DEVELOPMENT REVIEW COMMITTEE (DRC) COMMENT REPORT

Project Name: Jalil A. Shariz and Zahra Bahrami / Boruj Tower

Case Number: PRE15006

Request: Pre-DRC Item: Five (5) Multi-Family Units

PROPOSED SITE PLAN
BORUJ TOWER
2197 N. OCEAN BLVD
FORT LAUDERDALE, FL 33305

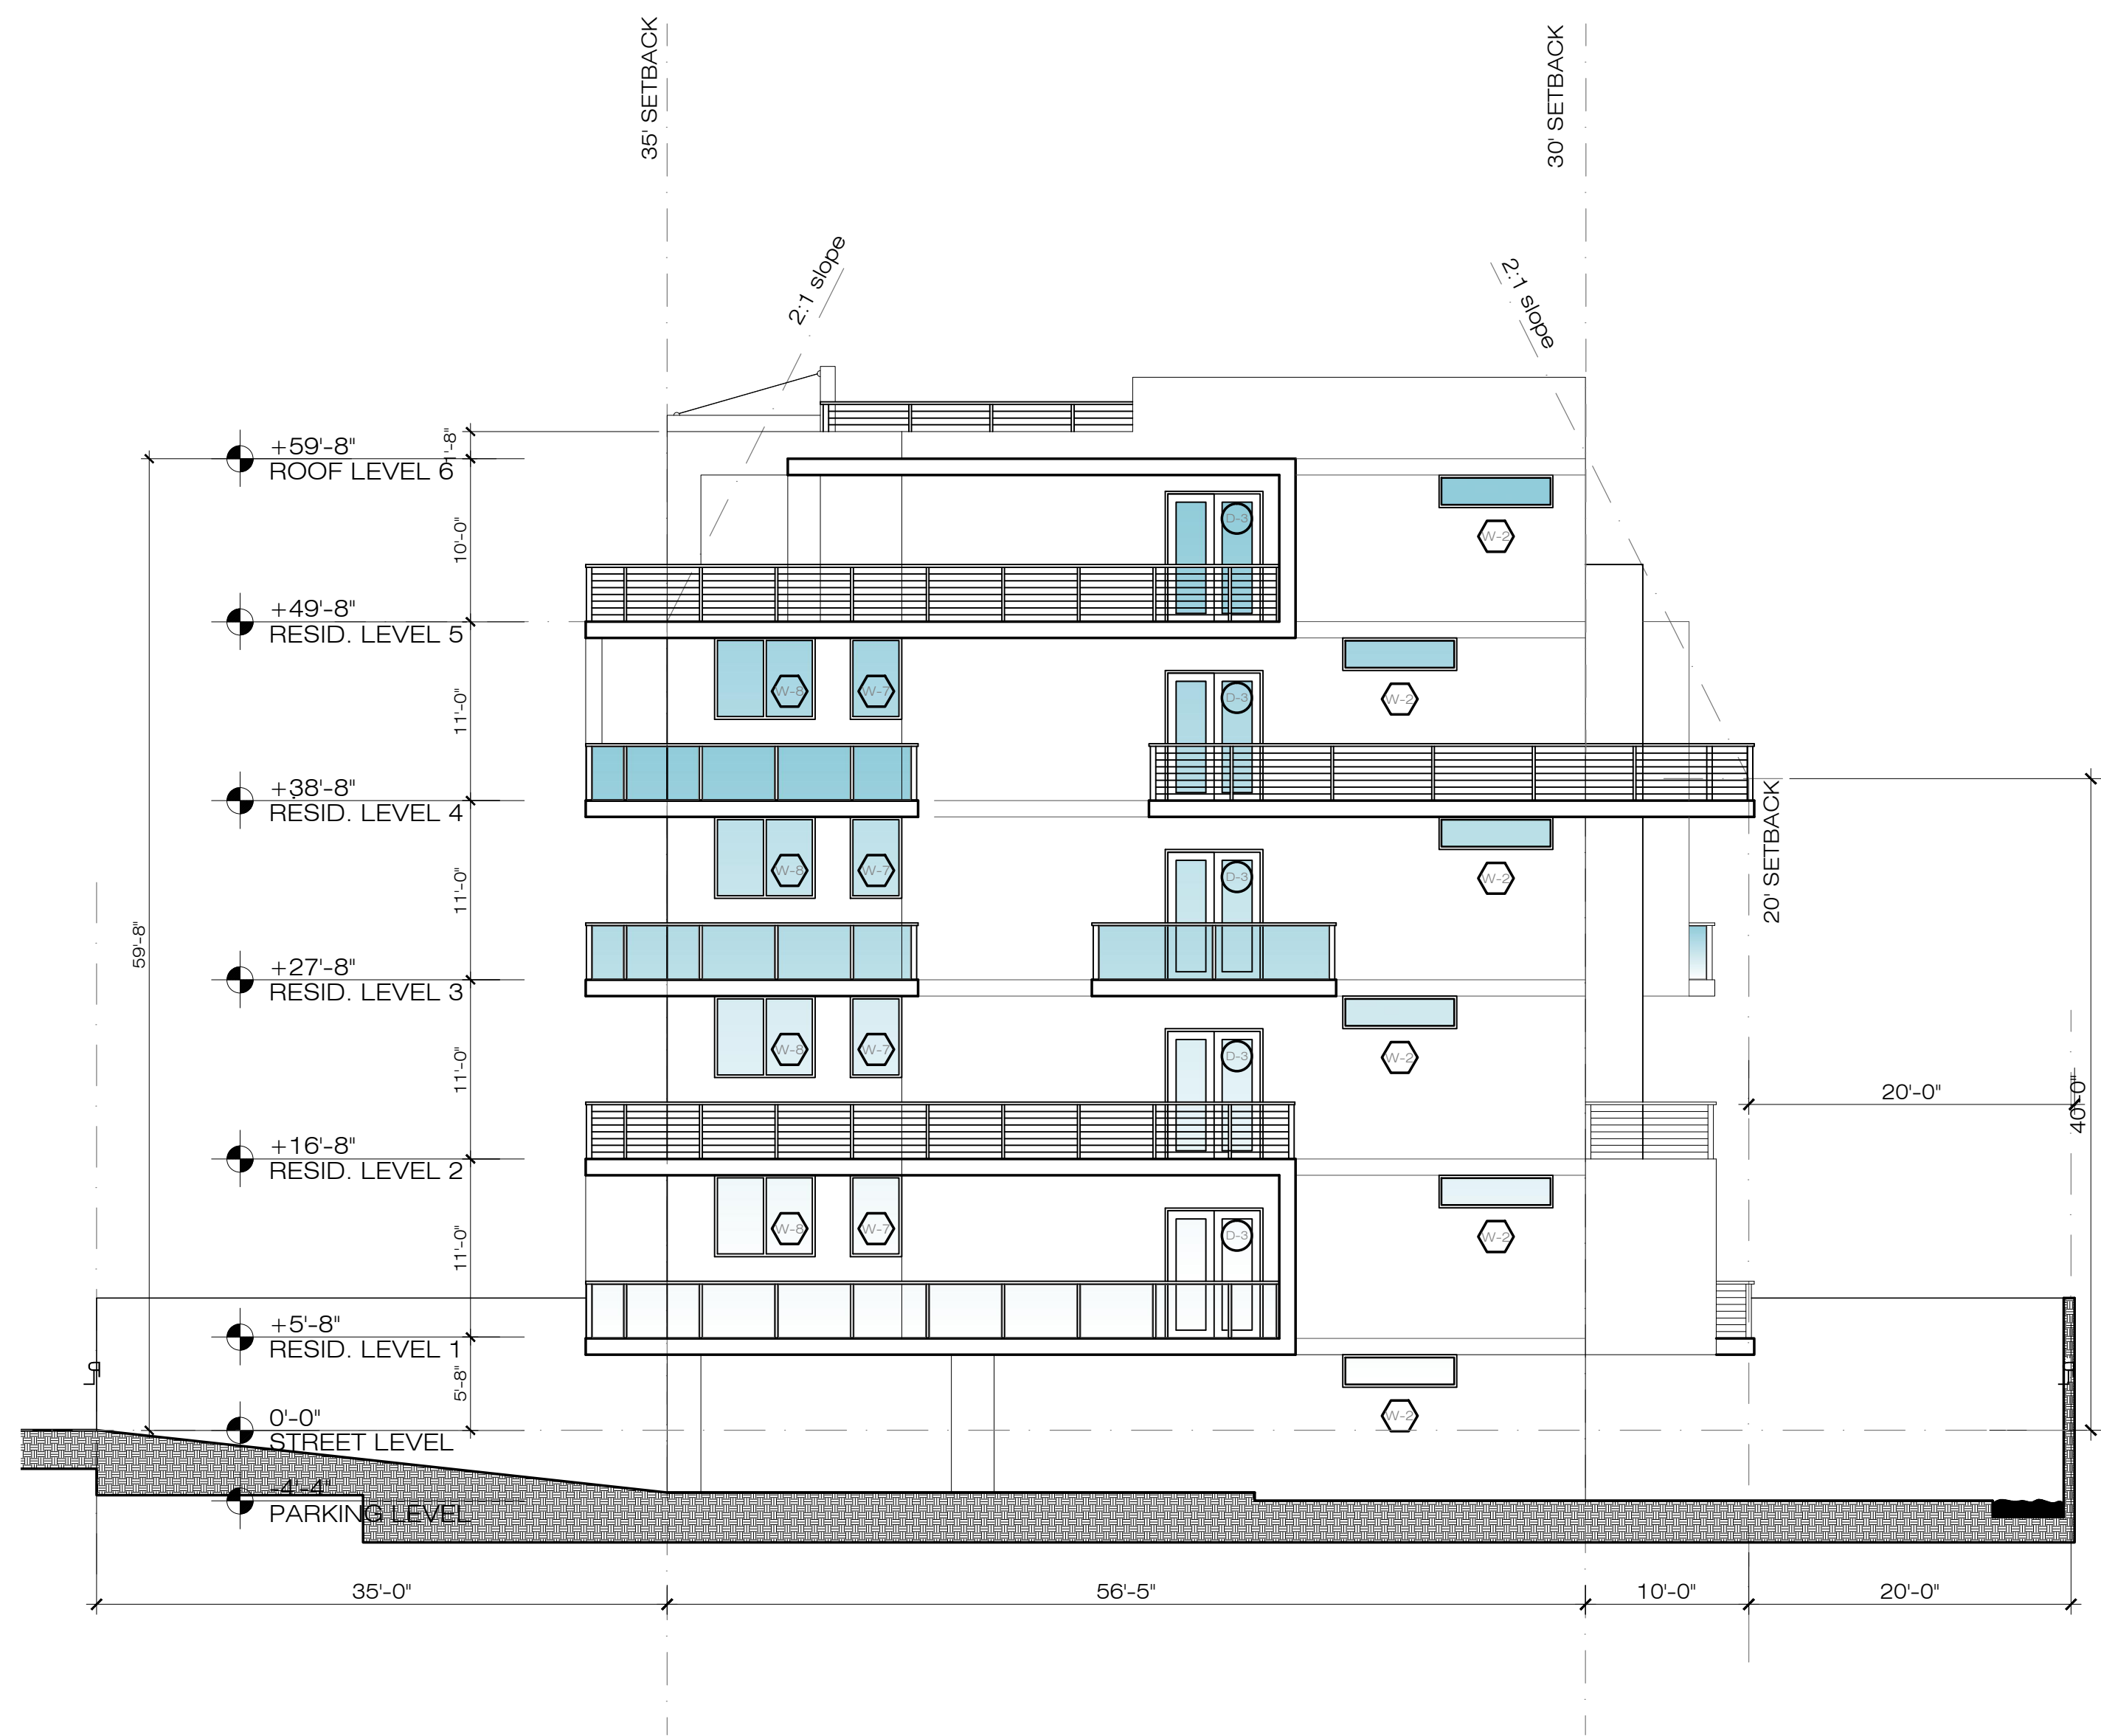
9. On-site parking encroaches within 10' Right-of-Way dedication to FDOT; discuss relocation or elimination of this parking stall.
10. Per ULDR Section 47-20.9.A, sloping floor grades shall not exceed five percent (5%) for ninety (90) degree parking stalls.

12. Sheet SP-3 (North Set Back Elevation), Sheet A-5 (South Elevation) & Sheet A-6 (North Elevation): Elevations show proposed driveway ramp from street level into parking garage extending to 35' building setback line, but Site Plan (Sheets SP-1 & SP-2) shows 12:1 ramp slope extending an additional 20' beneath the building.
